CLARIFICATION # 12

Contract Title: Request for Bidding - Procurement of Plant, Design, Supply, and Installation for Five (5) Energy Storage Systems in FOGO Island, SANTO ANTÃO Island, SÃO NICOLAU Island, MAIO Island and BRAVA Island Cabo Verde

RFB Reference No.: 016/REIUP/UGPE_2

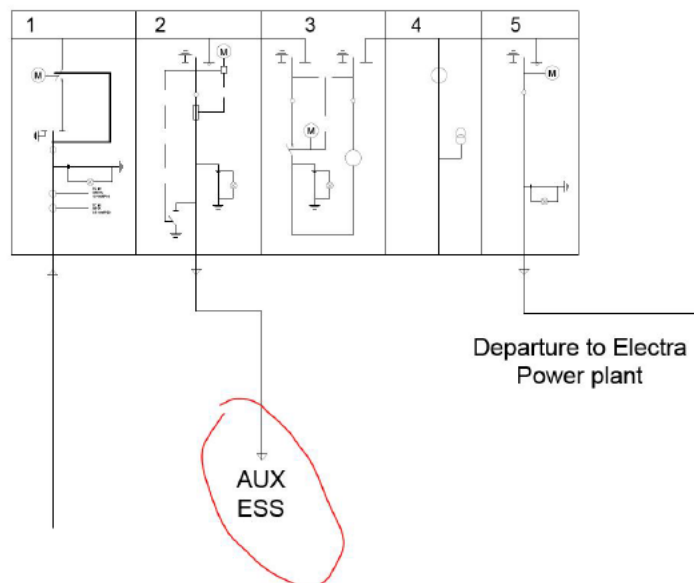
QUESTION 61: *According to the requirements of the bidding documents, the contractor needs to provide 2 auxiliary transformers as backups for each other. According to the single-line diagram, a 20kV medium-voltage switchgear needs to provide a circuit to the ESS auxiliary power supply. According to this single-line diagram, the contractor needs to configure a 20/0.4kV auxiliary transformer. As an exception, can we set up an auxiliary transformer on the low-voltage side of the PCS? For example, if the low-voltage side of the PCS is 0.69kV, can we set up a 0.69/0.4kV transformer and integrate it into a box with the PCS to reduce the overall footprint?*

ANSWER N° 61: The Single Line Diagrams are only provided for information. Please refer

to the Employer's Requirements - Scope of work #7.4.3. Please refer to the ITB 14.3 : Alternative technical solutions shall not be permitted.

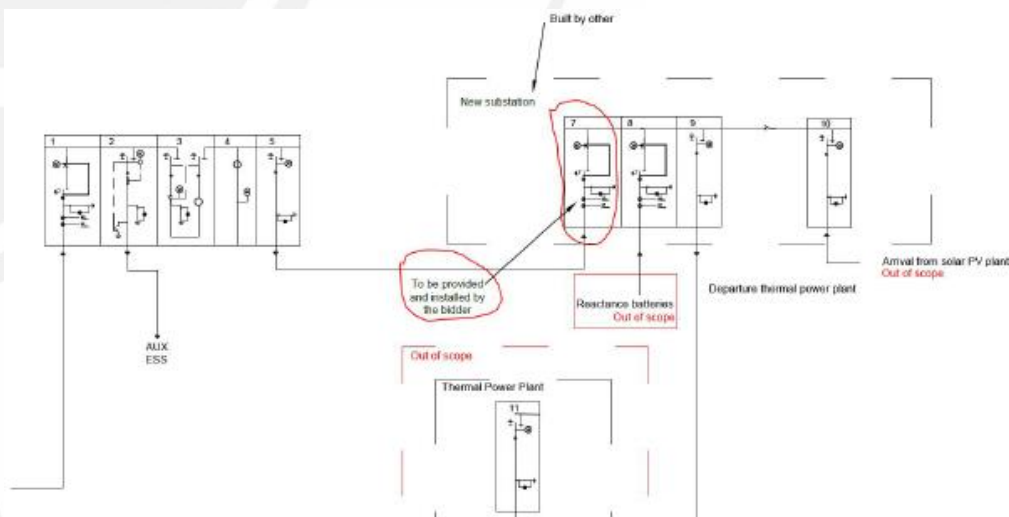
QUESTION 63: *The single-line diagram of the Santo Antao Island project clearly shows that the bidder needs to provide a switchgear to connect to the 20kV busbar of the thermal power plant. However, the single-line diagrams of the other four projects do not specify whether this is needed. Please confirm whether it is required?*

ANSWER N° 63: The Single Line Diagrams are only provided for information. Please refer to the Employer's Requirements - Scope of work #7.4.2. The Bidder shall provide the switchgear to connect the BESS to the Grid at the connection point (new substations in Santo Antao and Brava, Electra power plant in Sao Nicolau and Fogo, Solar PV plant in Maio. Note that the Bidder shall also supply and install a MV 20 kV-cable and terminations between the BESS and the Electra Power Plant in Maio. This cable will be the permanent

connection of the BESS to the grid once the rehabilitation works will be finished in the Electra Power Plant.
